Project Name: **UNIVERSITY OF CALIFORNIA, MERCED**
CLASSROOM & ACADEMIC OFFICE BUILDING
Project No.: **900290**

ADDENDUM NO. 2

February 28, 2014

Removable Bollard Detail

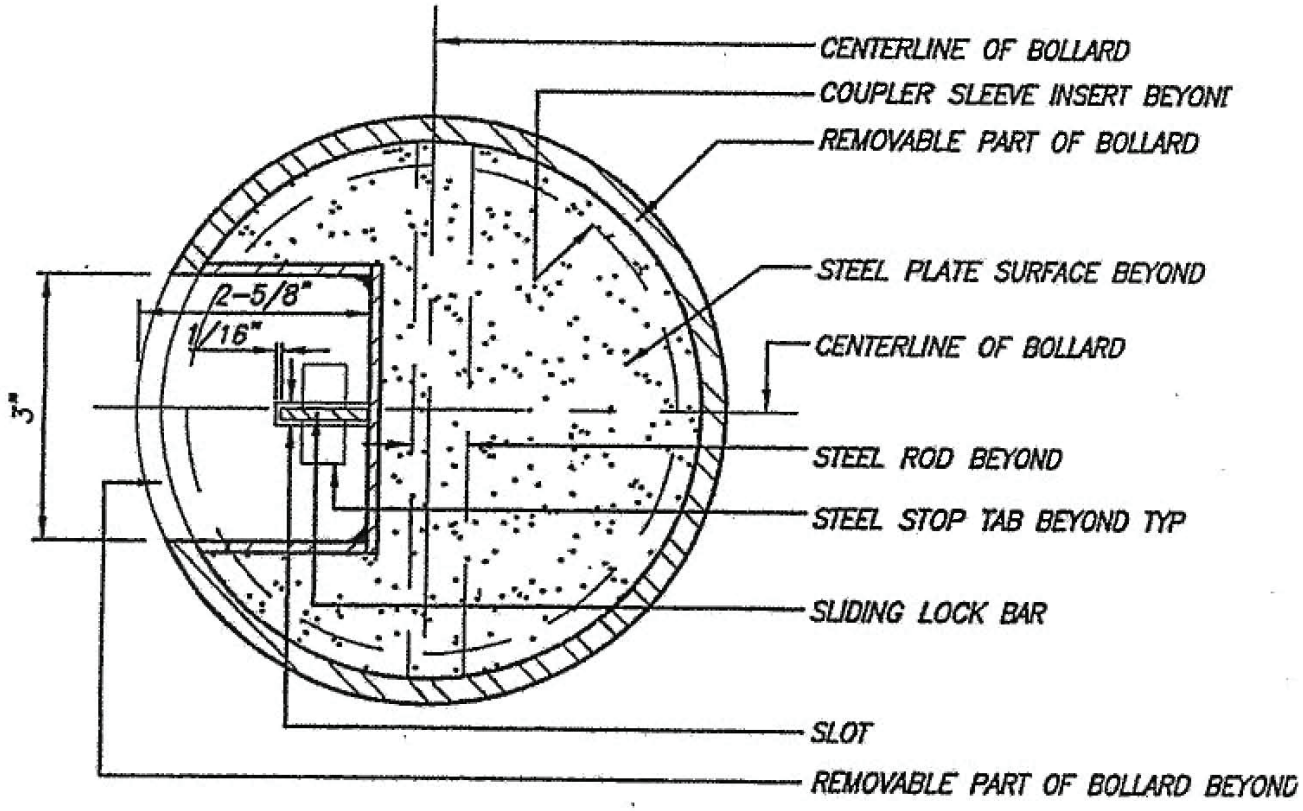
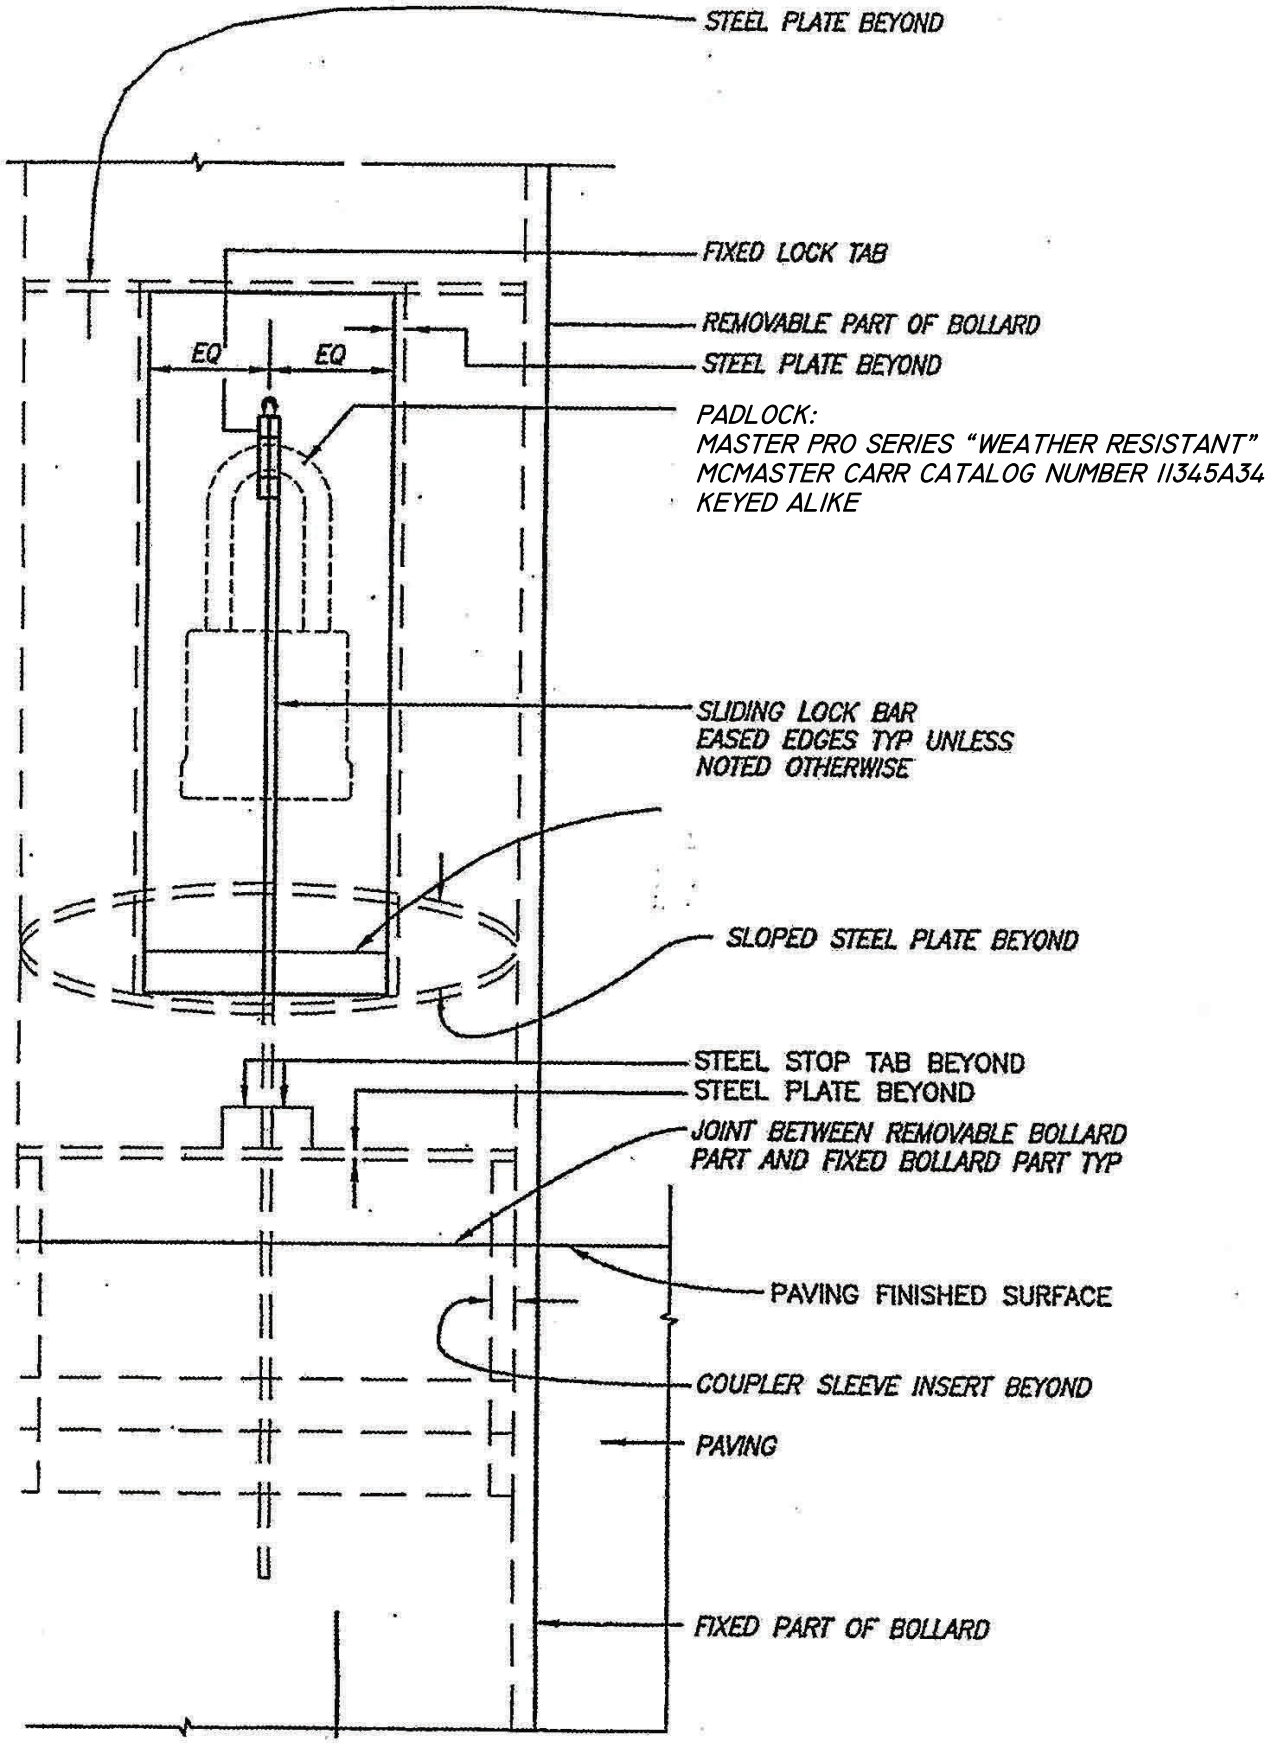
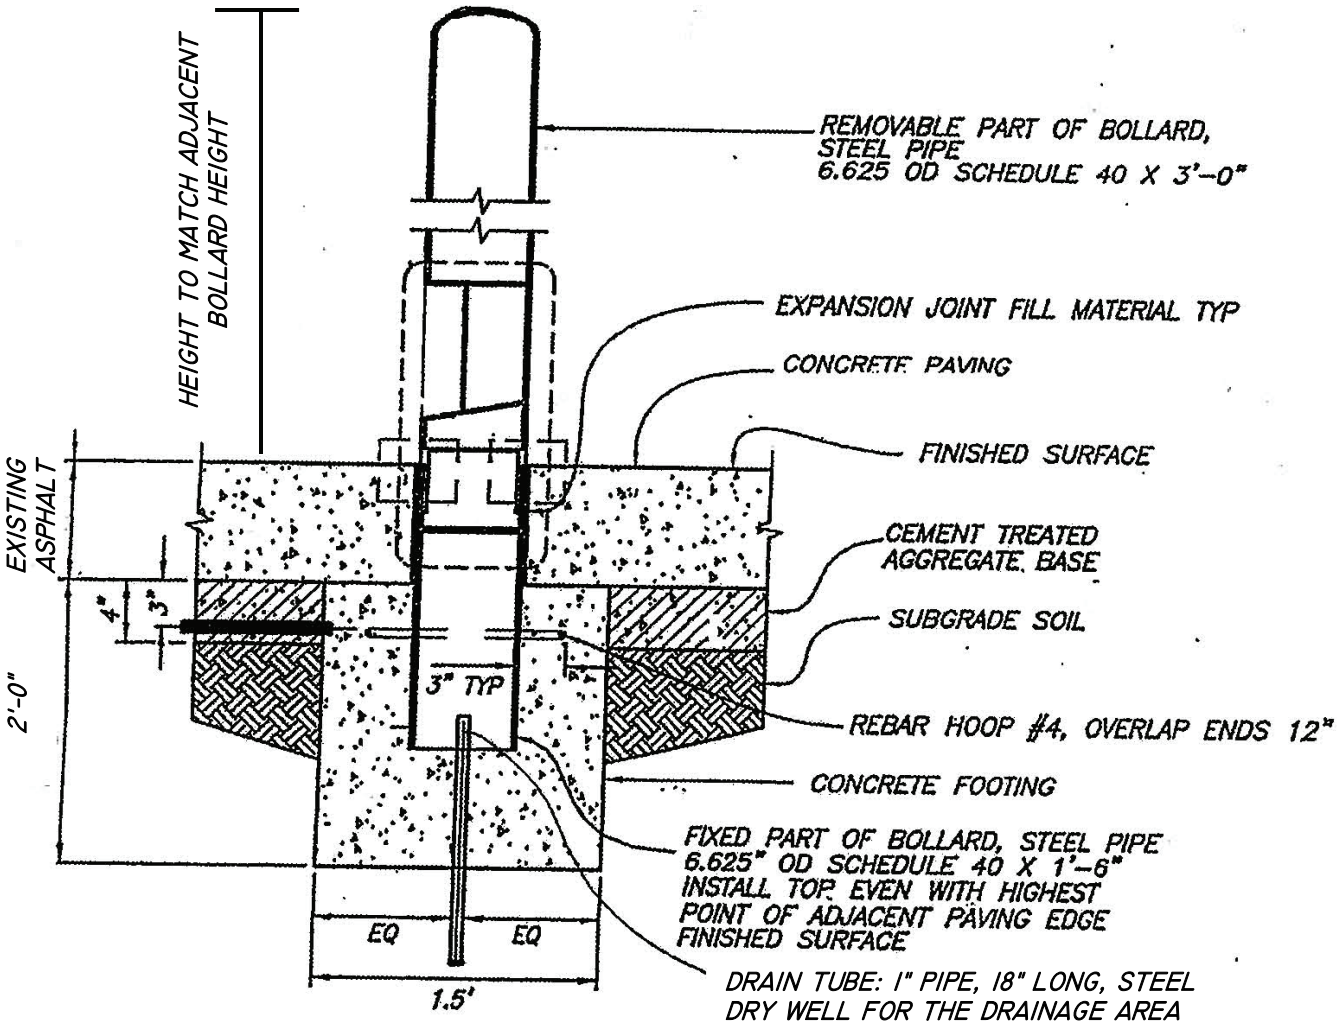
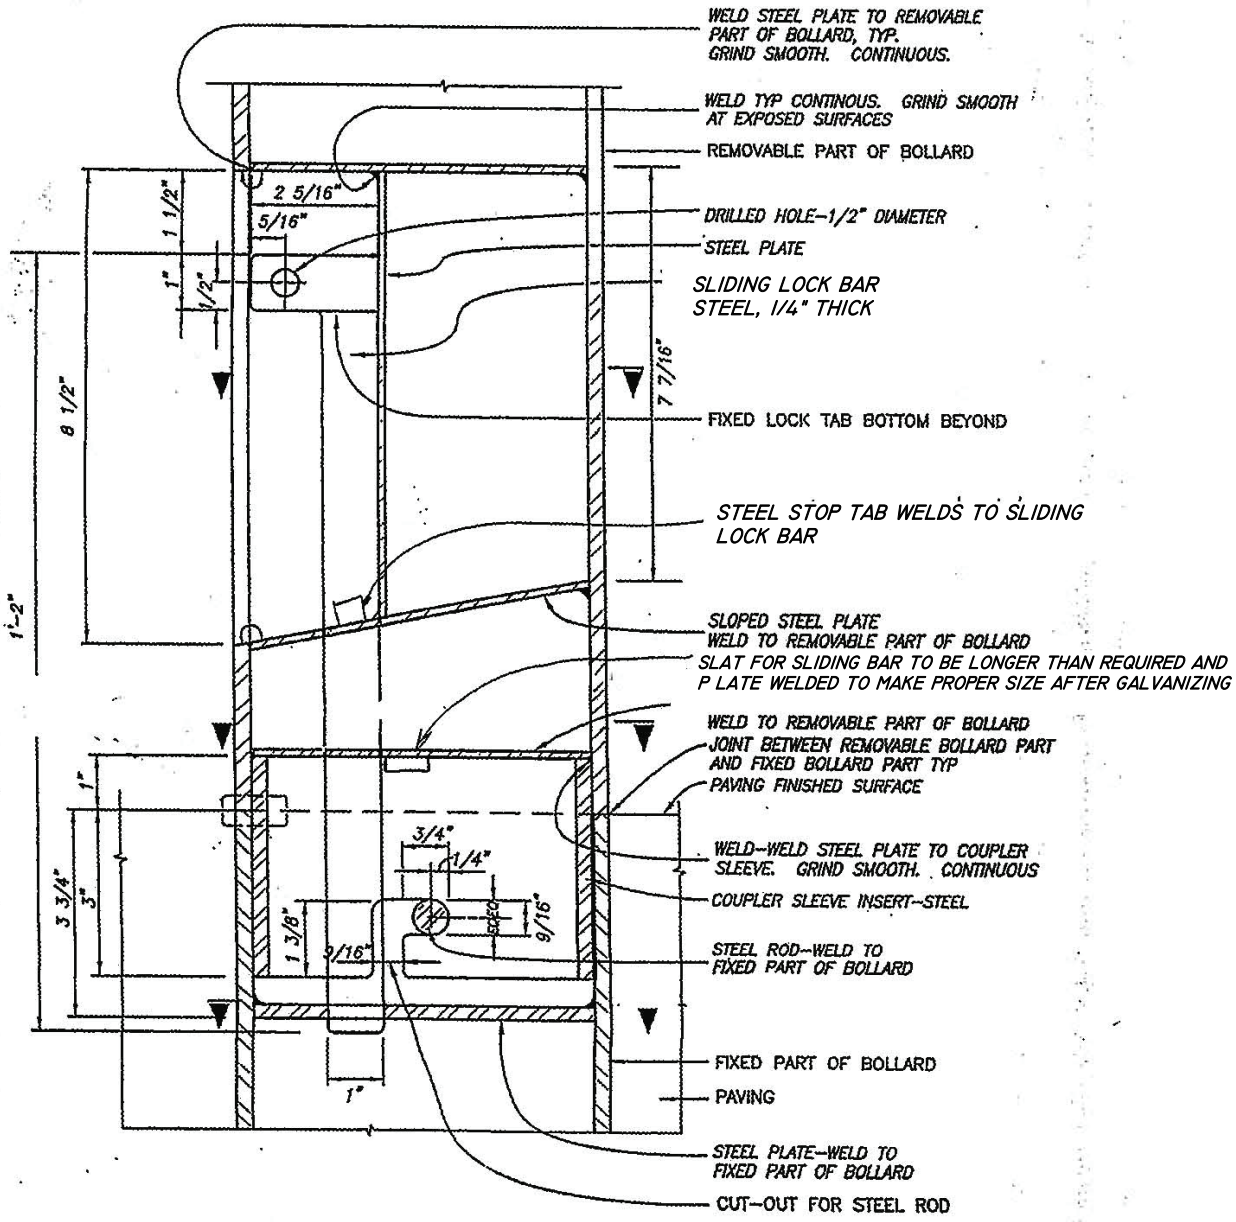
4. Q. Could you furnish me with the Campus Standard for the removable pipe bollards per Site Furnishings 125740 2.4B? I see the fixed bollards have been specified as Creative Pipe. (RFI030)

A. Attached to this Addendum 2 are the requested details for the removable pipe bollards including finish requirements.

Current location of trees
Gingko Tree to be
relocated from CAOB
Scholars Lane

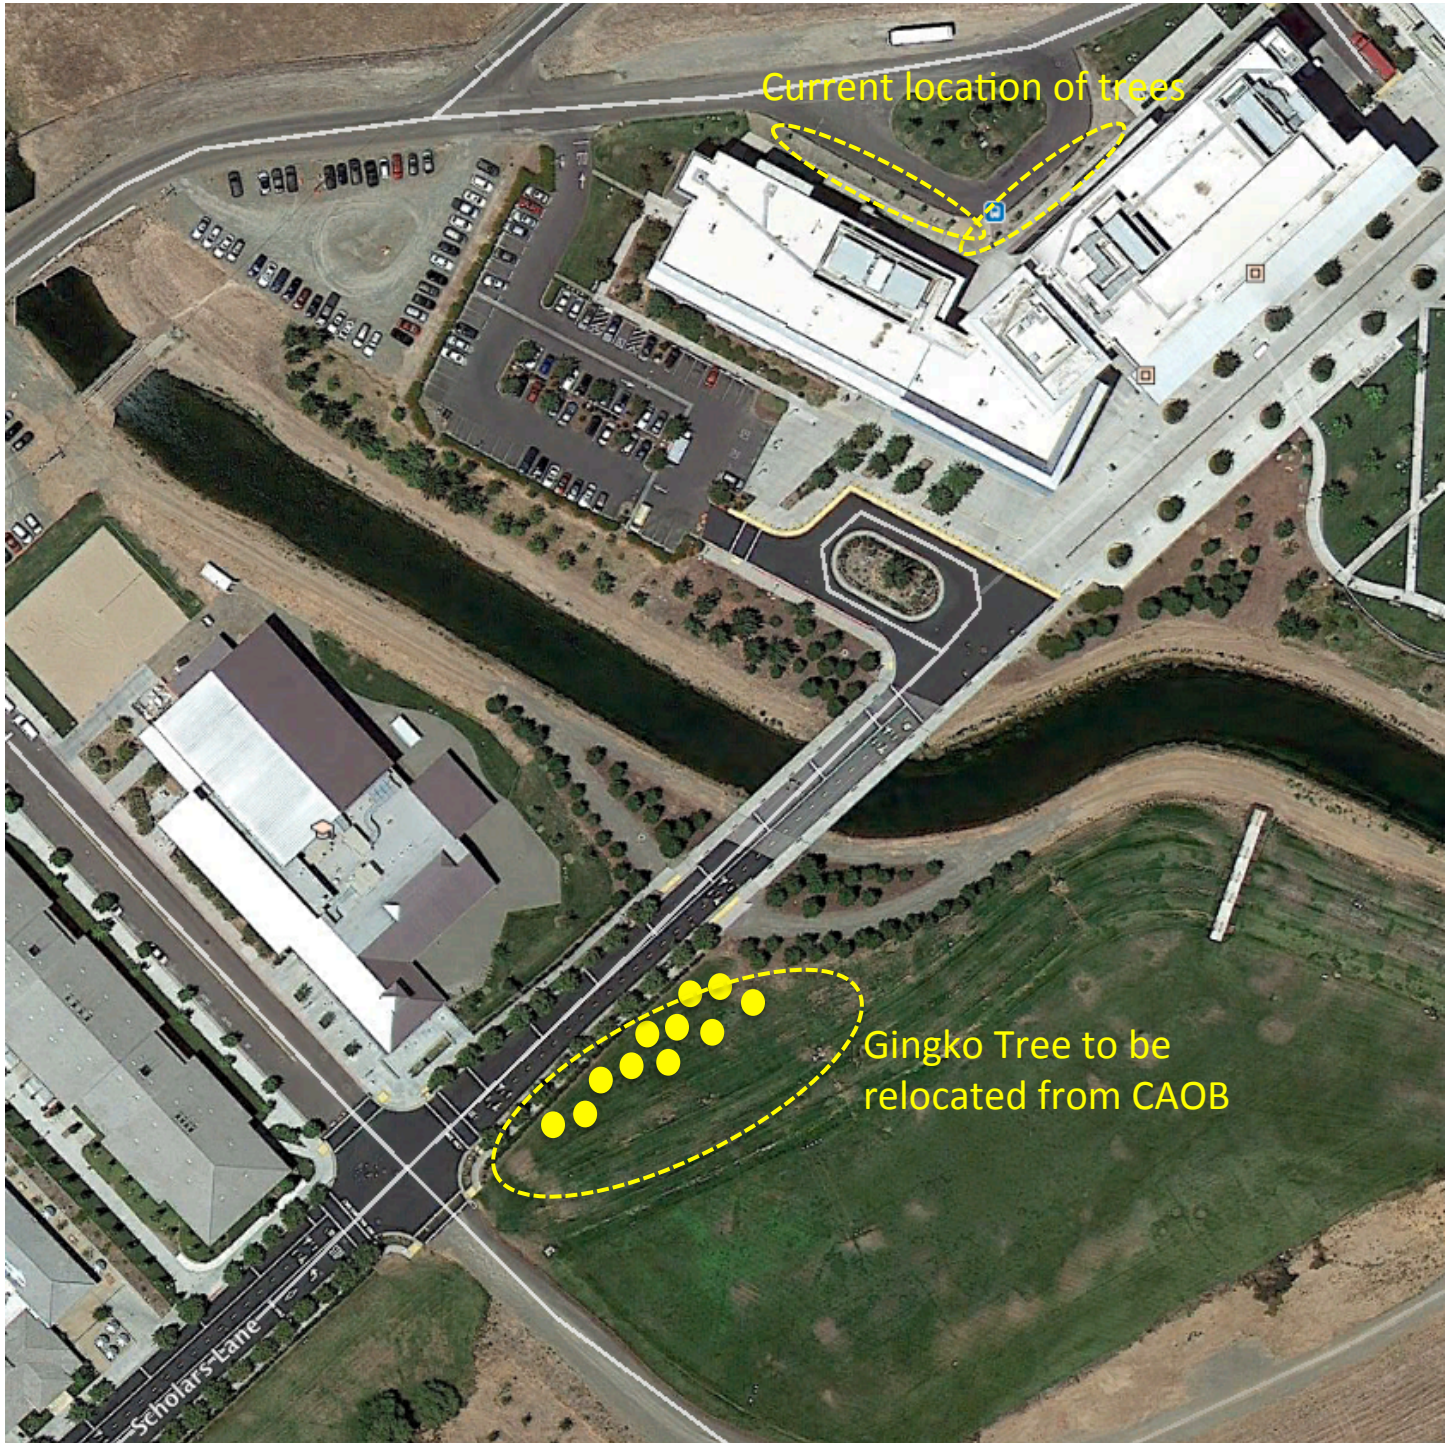
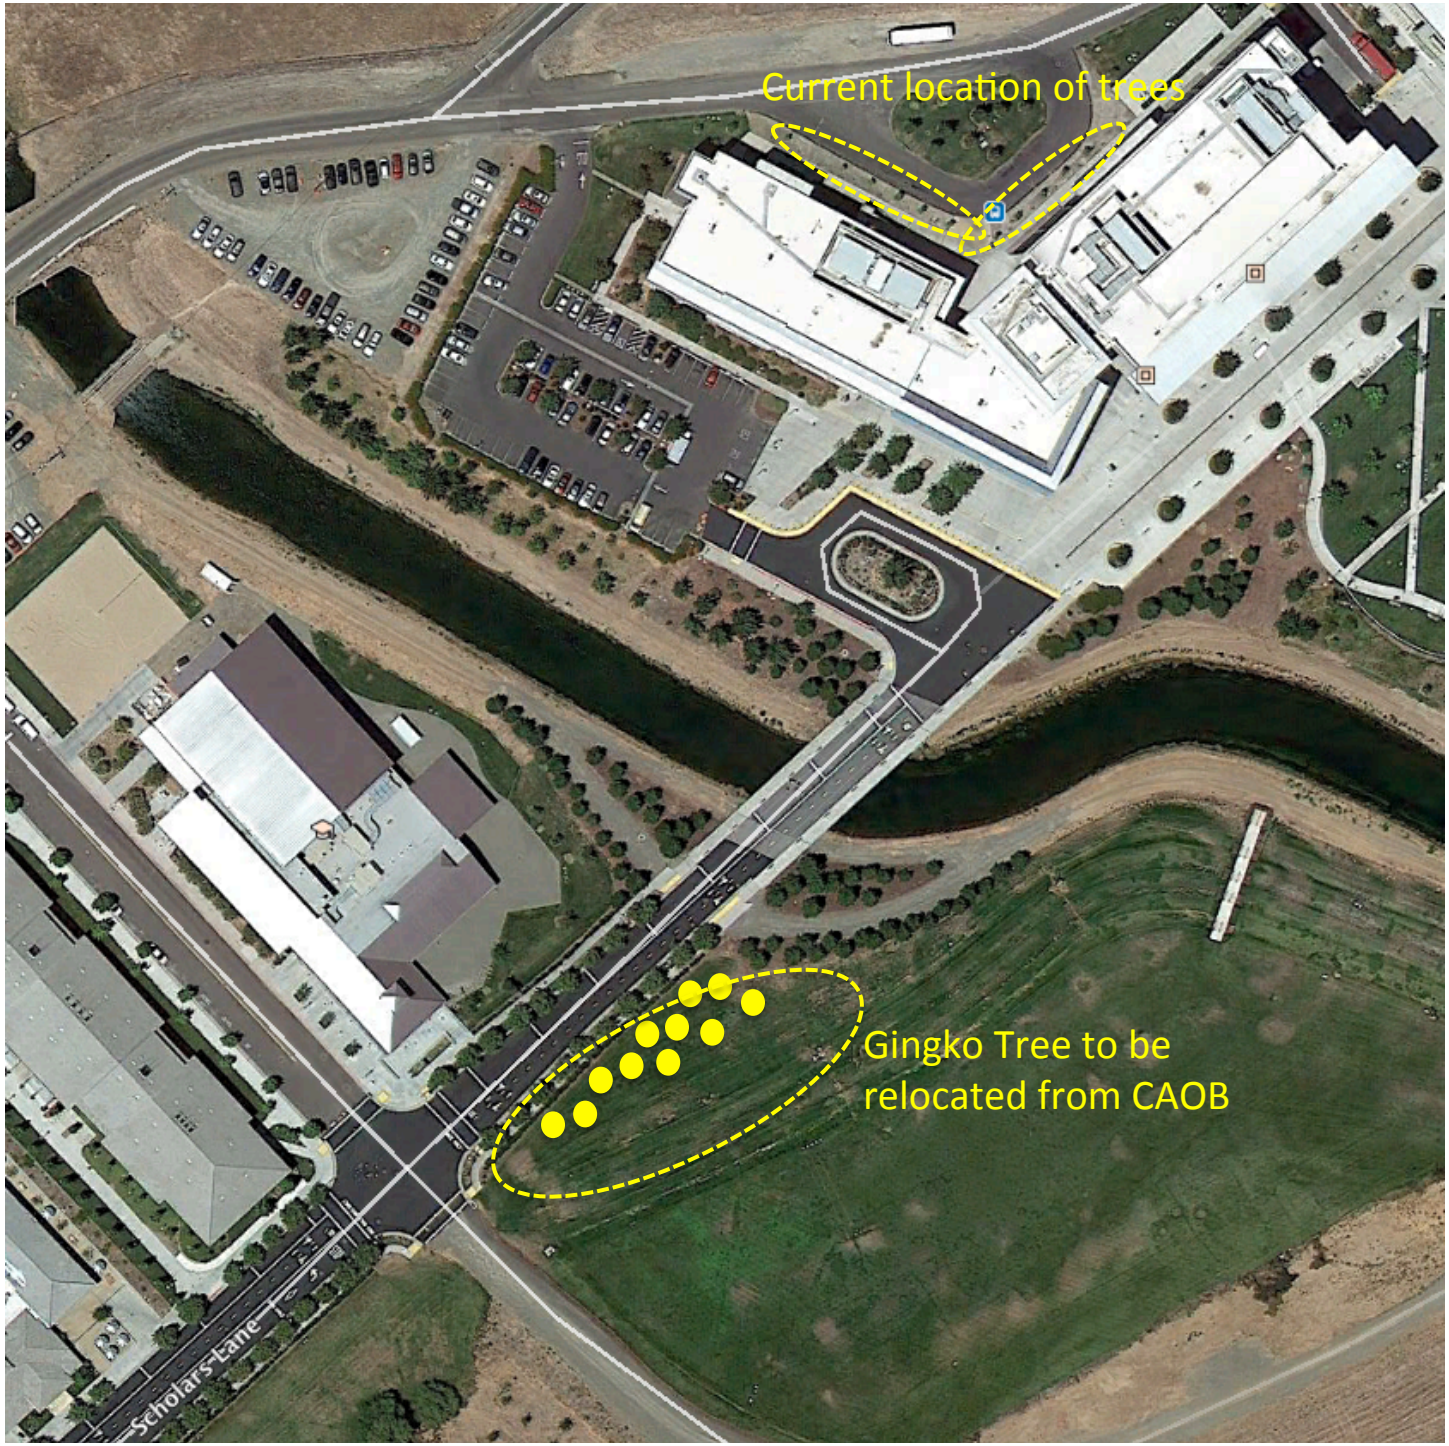
2. Section 01 22 00 1.3.A.3 Unit Prices: **ADD Unit Price No. 3, Remove & Relocate Gingko tress and Exhibit ADD 2.**

Scale: N.T.S.
Drawn By: RAB/SEC
Project Number: 2012040
Sheet Number: C5.01

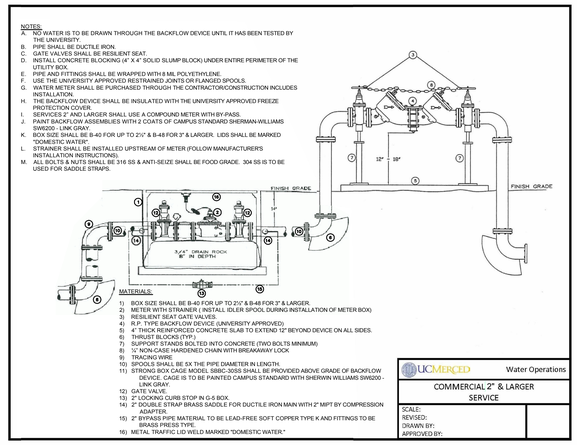
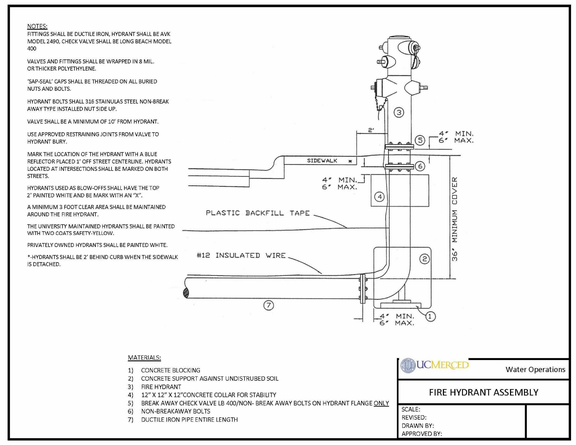
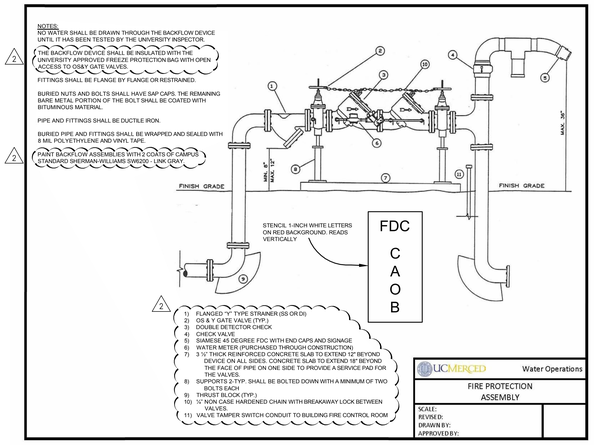
C4.01	Utility Plan	Callout and detail references added for irrigation backflow preventer (UC Merced directive)
C5.01	Construction Details	Detail 6 updated water meter service portion and notes added; detail 8 notes added (UC Merced directive)
C5.02	Construction Details	Added detail 10 irrigation service (UC Merced directive)
L2.02	Irrigation Details	Detail 2 deleted, note added to refer to Civil for campus standard water service (UC Merced directive)
A0.01A	Index Sheet	Sheet updated with Addendum No. 2 inclusions
A2.11	First Floor Plan	Note added, remove area drain at Rm 190. (Add Alt. #2)
A2.21	Lantern Plan	PV Structure indicated (Add Alt. #3)
A3.10	Overall Building Elevations	Note added for future louver location on North elevation, indicated on elevations (Add Alt. #3)
A4.65	Exterior Section Details	Sheet note added, concrete keynotes spec. section reference updated (Clarification)
A5.01	ENLARGED STAIR PLANS AND SECTIONS	Concrete keynotes spec. section reference updated (Clarification)
